FINAL ENVIRONMENTAL IMPACT STATEMENT FOR CYPRESS CREEK WATERSHED

LAUDERDALE COUNTY, ALABAMA
AND
WAYNE COUNTY, TENNESSEE

JANUARY 1976

FINAL ENVIRONMENTAL IMPACT STATEMENT

TYPICAL SECTIONS OF CHANNEL WORK

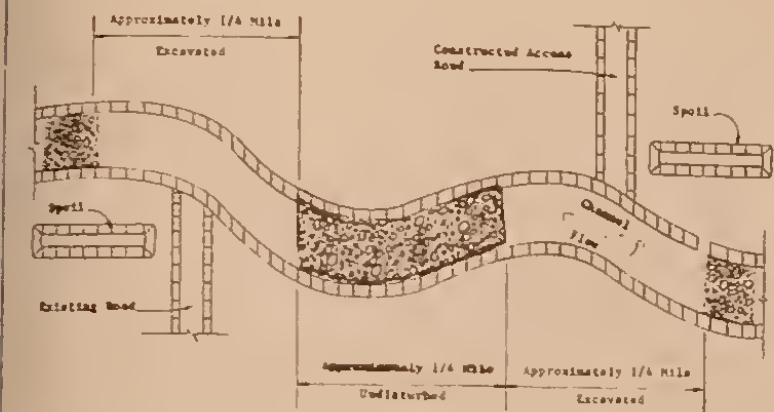
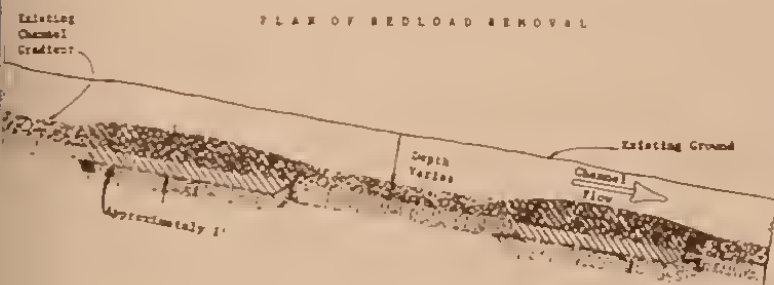
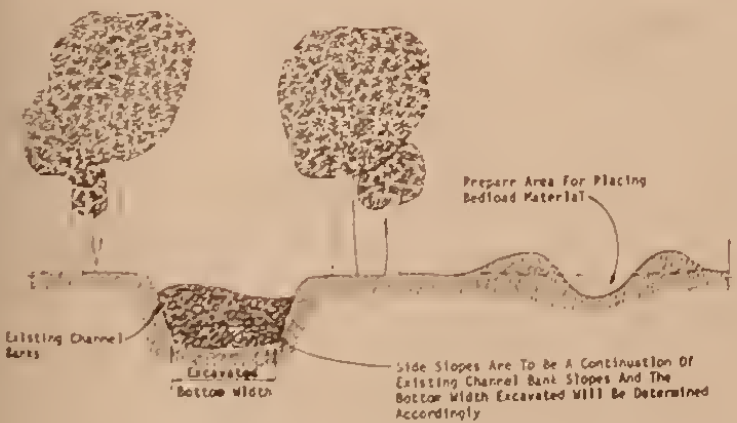
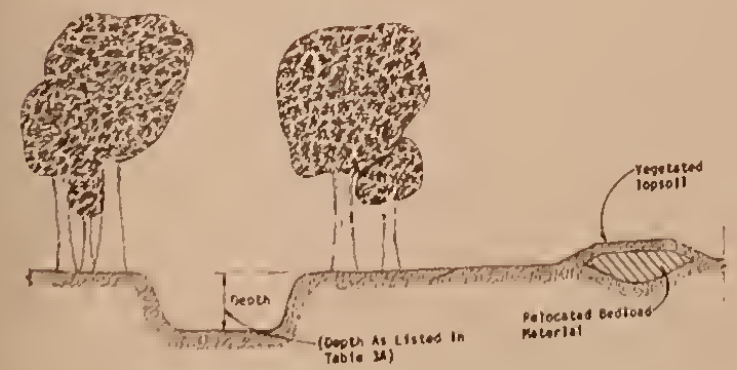
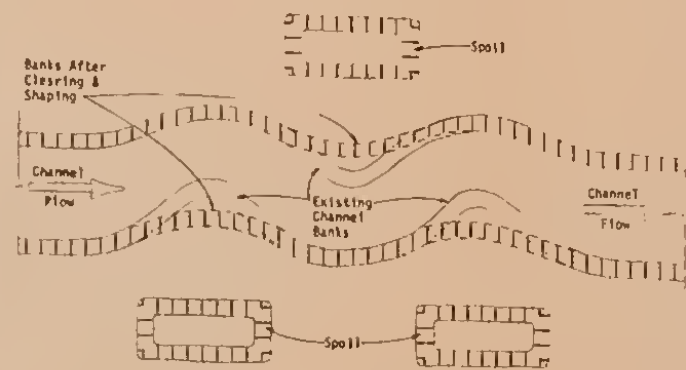
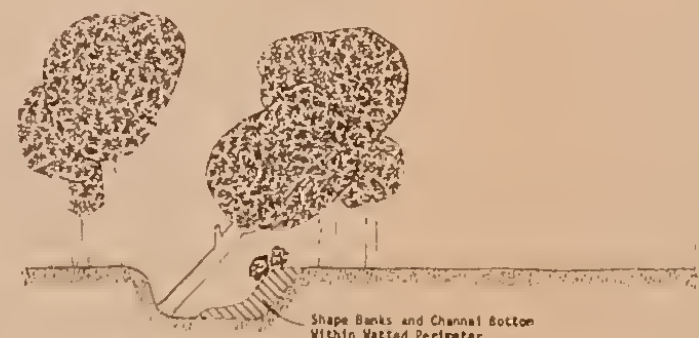
I am very much opposed to "channel work", planned for 14.4 miles of major streams in this project. It is well known and documented by extensive studies that stream channelization as planned for this project destroys wildlife habitat, causes damage to streambanks and their biological communities, lowers water tables, and aggravates downstream flooding conditions. Channelization of streams should not be considered as an appropriate technique in watershed development.
